PRESERVES OF VENICE
 Border Road
 City of Venice, Florida

**TREE
 REMOVAL**

REVISION TABLE (6/7/17)

LANDSCAPE PLAN

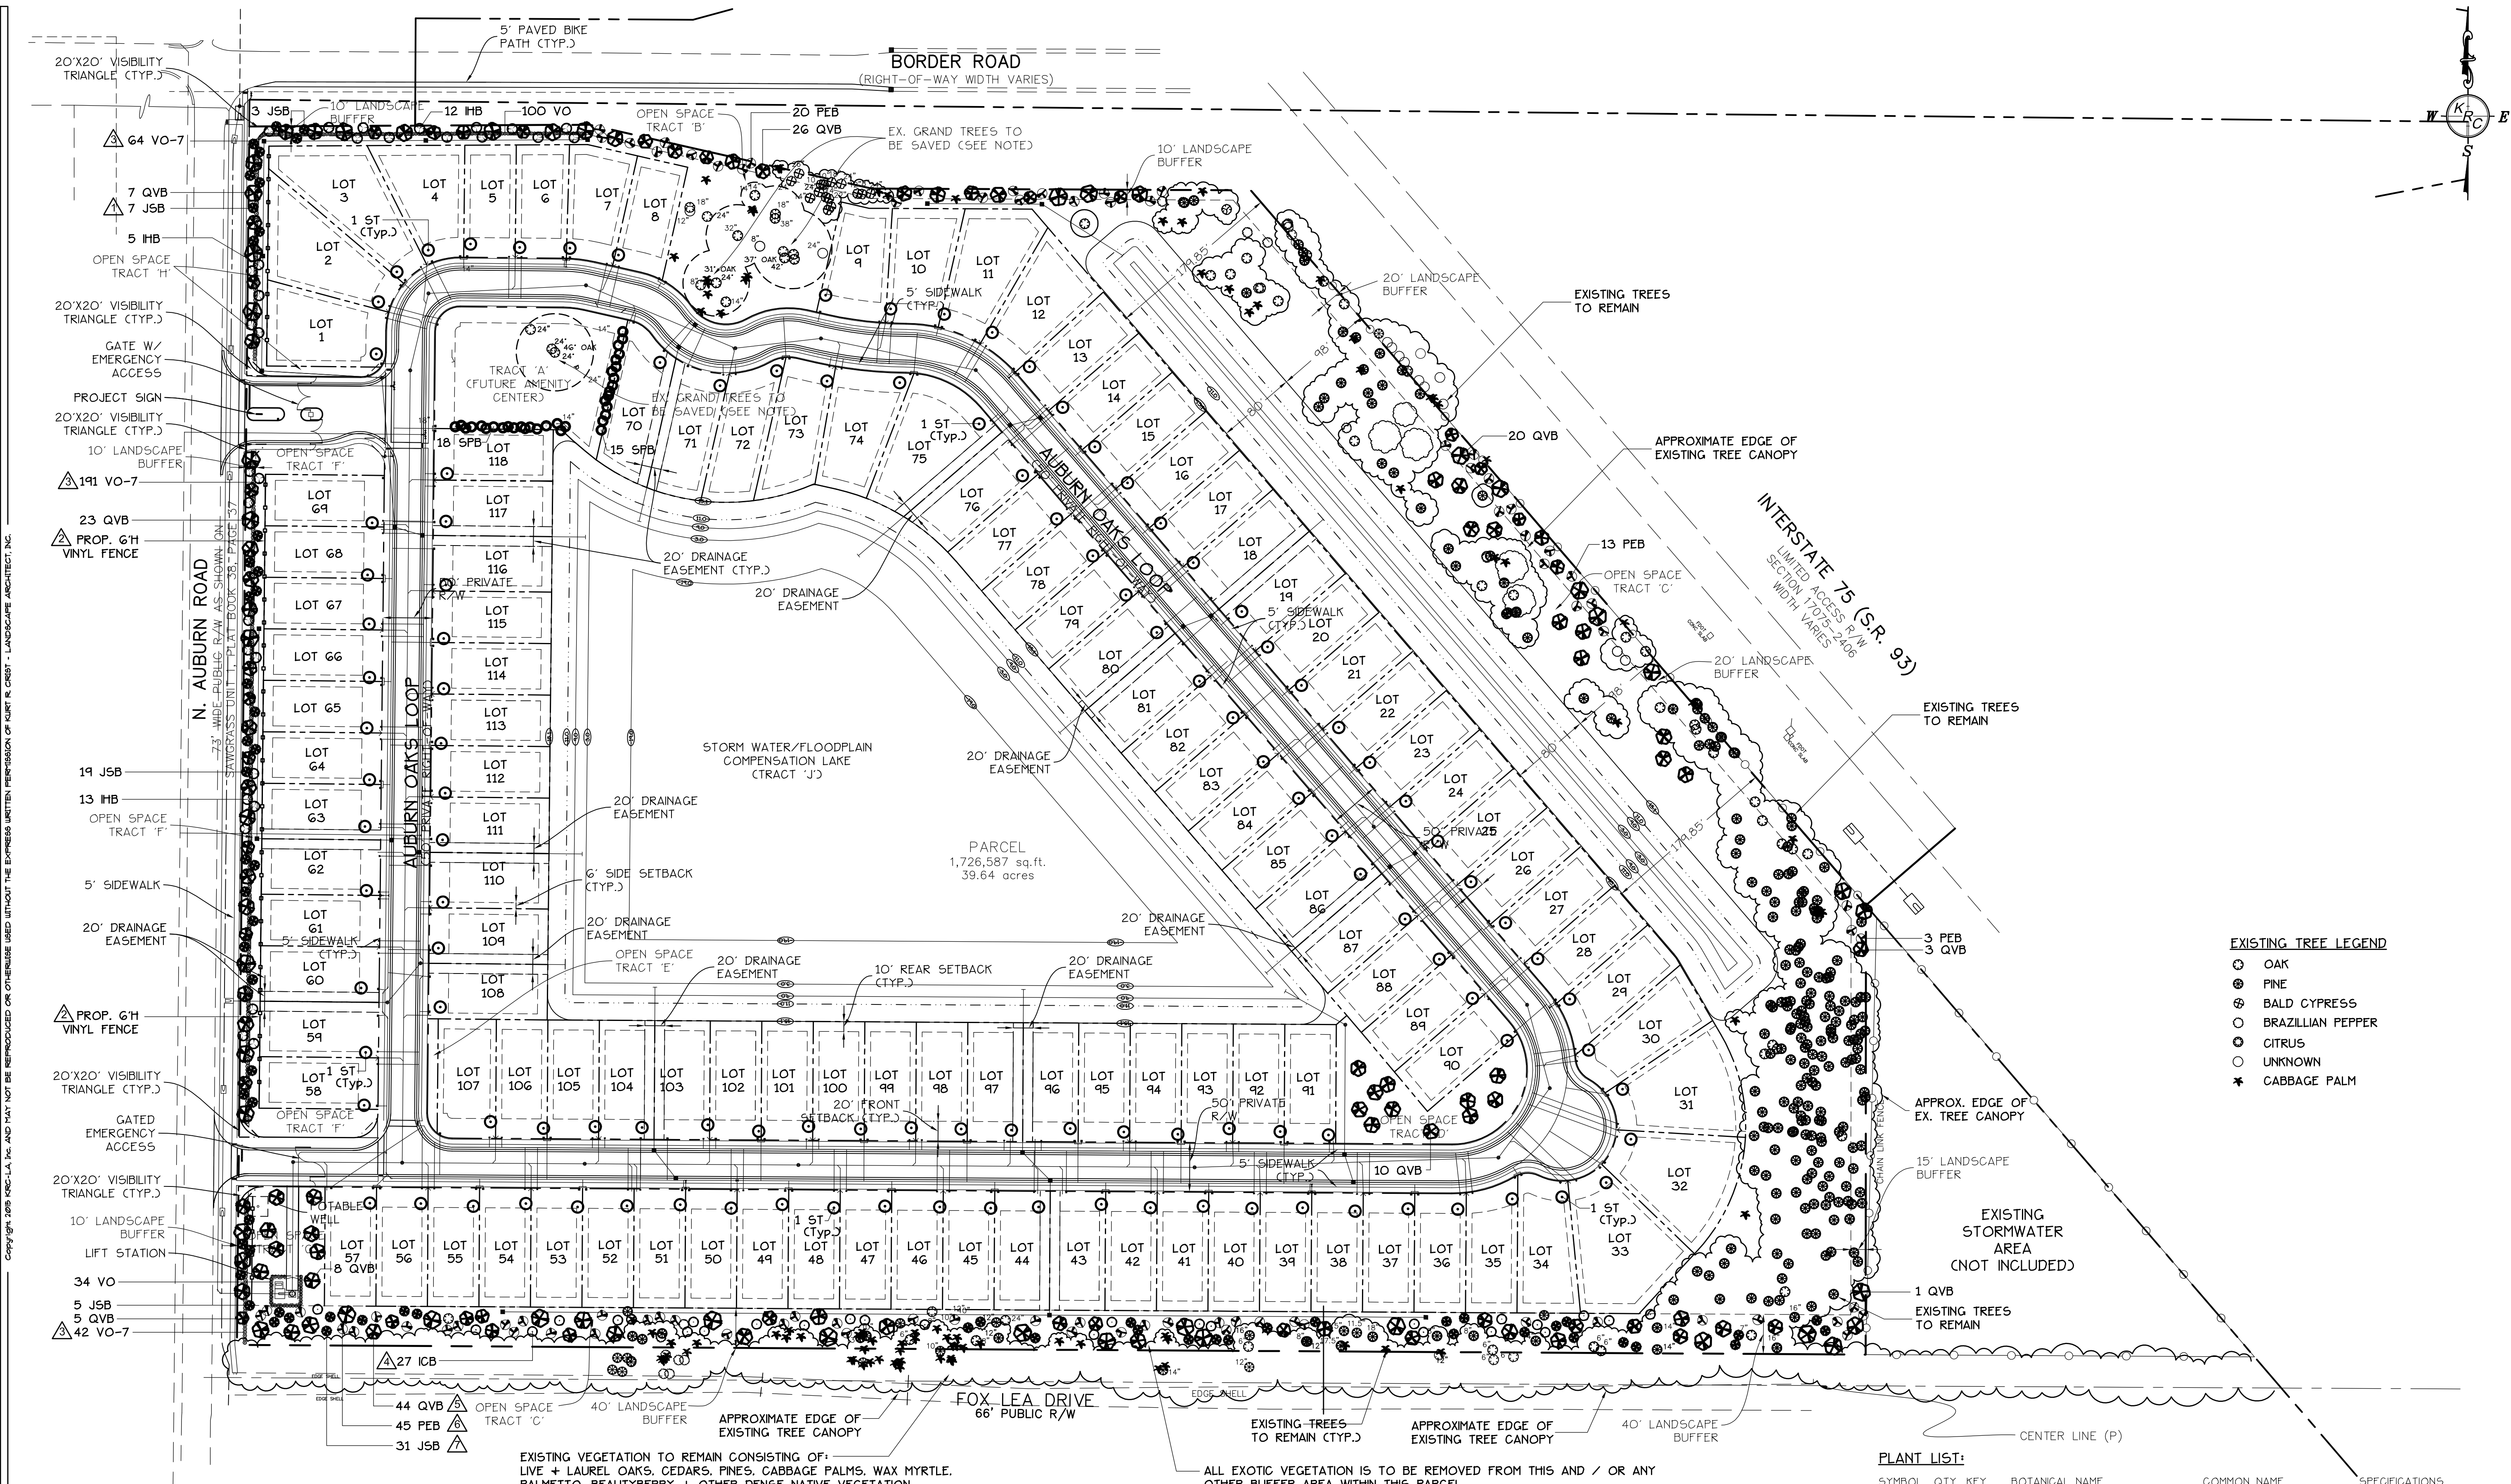
- ▲ Add 1 J5B (So. Red Cedar) tree
- ▲ Add 6' High Vinyl Fence
- ▲ Increased Viburnum size from 24"ht. 3 gal. to 36"ht. 7 gal.
- ▲ Add 11 ICB (Dahoon Holly) tree
- ▲ Add 3 QVB (Live Oak) tree
- ▲ Add 15 PEB (Slash Pine) tree
- ▲ Add 3 J5B (So. Red Cedar) tree
- ▲ Add 6' High Vinyl Fence

1230.35 l.f. (Less Ingress-143.64) / 50 = 21.7	22 TREES REQUIRED
35 QVB Live Oak 10'h. 3'cal.	84 TREES PROPOSED
31 JSB So. Red Cedar 10'h. 3'cal.	⚠ Add 1 JSB (So. Red Cedar) tree
18 IHB E.P. Holly 10'h. 3'cal.	Incorrect original calculation was less 5 IHB
297 VO-7 Sweet Viburnum 36'h. 7 gal.	297 SHRUBS PROPOSED
	⚠ Increased Viburnum size from 24'ht. 3 gal. to 36'ht. 7 gal.

1.644.32 l.f. / 50 = 32.8	33 TREES REQUIRED
44 QVB Live Oak 10'h. 3'cal.	167 TREES PROPOSED
45 PEB Slash Pine 10'h. 3'cal.	⚠ Add 3 QVB (Live Oak) tree
31 JSB So. Red Cedar 10'h. 3'cal.	⚠ Add 15 PEB (Slash Pine) tree
27 ICB Dahoon Holly Tree 10'h. 3'cal.	⚠ Add 3 JSB (So. Red Cedar) tree
52 Ex. Trees (22 Pines, 7 Oaks, 23 Palms)	⚠ Add 11 ICB (Dahoon Holly) tree
	Removed Additional Trees (3 Pines, 1 Oak)
	Added Existing Palms (23)
